SERVICE *No. 965* BULLETIN

DATE: SEPTEMBER 1, 1993

Inspection of Flap Lever and Bolt.

(OVER)
ATA: 2750

PA-28 MODELS WITH STAB. TRIM CRANK (OVERHEAD).

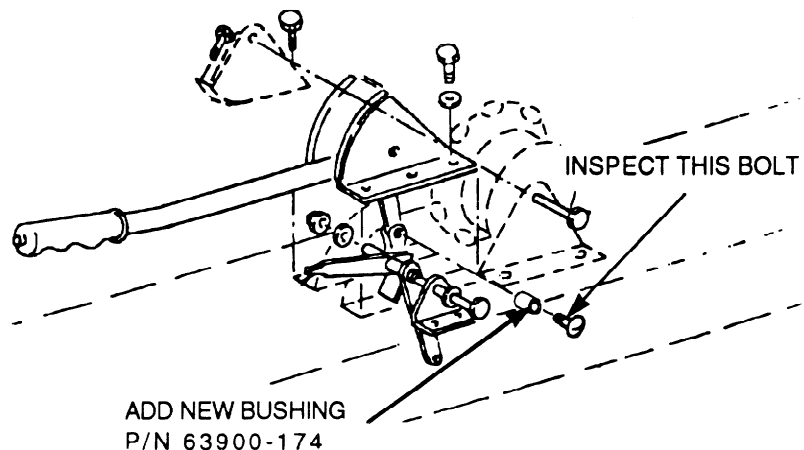
1. Remove royalite flap handle cover..
2. Remove flap handle mounting bracket attachment bolts and raise handle and bracket assembly to allow access to the flap control cable attachment bolt.
3. Remove and inspect cable attachment bolt for possible wear. If an AN23-10 bolt is installed or if wear is detected, replace existing bolt with a new Clevis Bolt (AN23-11) Piper Part Number 400-673.
4. Re-install hardware utilizing the new bushing Part No. 63900-174. Refer to Sketch A for hole enlargement.

PA-28 MODELS WITH STAB. TRIM WHEEL.

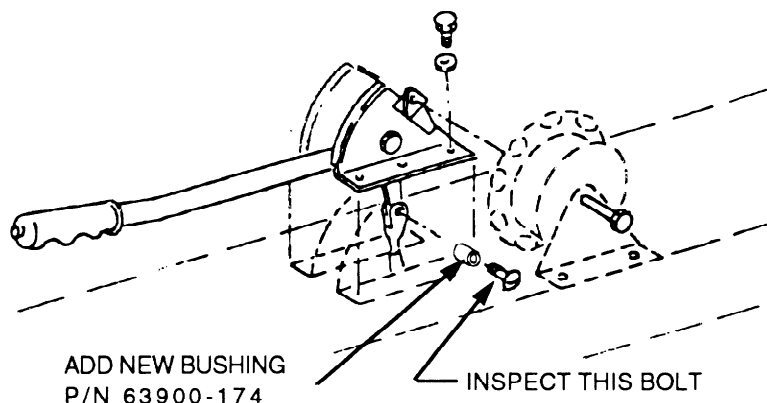
1. Remove royalite flap handle cover..
2. Loosen trim wheel attach bolt, remove trim wheel attach bracket bolts and remove bracket from top of tunnel..
3. Remove flap handle mounting bracket attach bolts and raise handle and bracket assy. to allow access to the control cable attach bolt
4. Remove and inspect cable attachment bolt for possible wear. If an AN23-10 bolt is installed or if wear is detected, replace existing bolt with a new Clevis Bolt (AN23-11) Piper Part Number 400-673.
5. Re-install hardware utilizing the new bushing Part No. 63900-174. Refer to Sketch A for hole enlargement.

PA-28R AND PA-32R MODELS

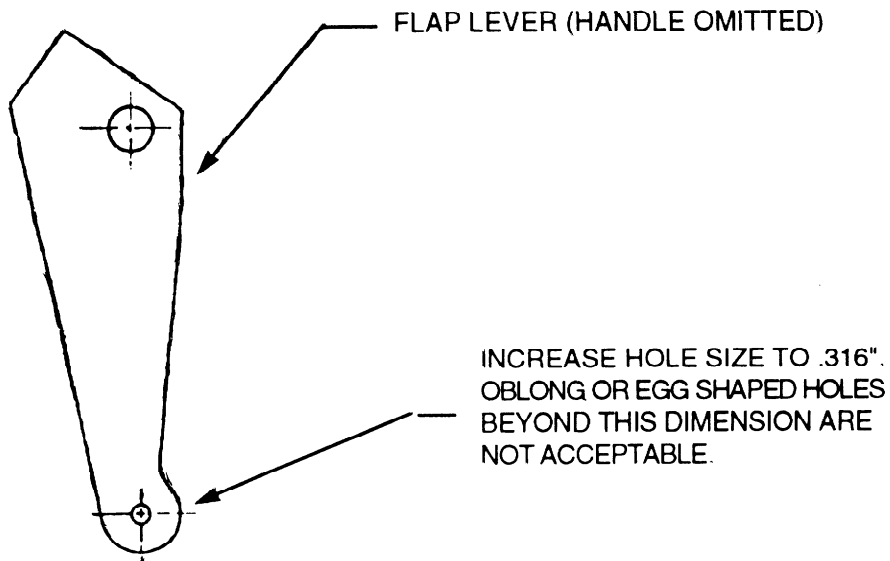
1. Remove royalite cover from flap handle, trim wheel and emergency gear lever.
2. Loosen trim wheel attach bolt, remove trim wheel attach bracket bolts and remove bracket from top of tunnel..
3. Remove the pivot bolt thru the emergency gear lever and the flap handle mounting bracket.
4. Remove flap handle mounting bracket attach bolts and raise handle and bracket assy. to allow access to the control cable attach bolt
5. Remove and inspect cable attachment bolt for possible wear. If an AN23-10 bolt is installed or if wear is detected, replace existing bolt with a new Clevis Bolt (AN23-11) Piper Part Number 400-673.
6. Re-install hardware utilizing the new bushing Part No. 63900-174. Refer to Sketch A for hole enlargement.
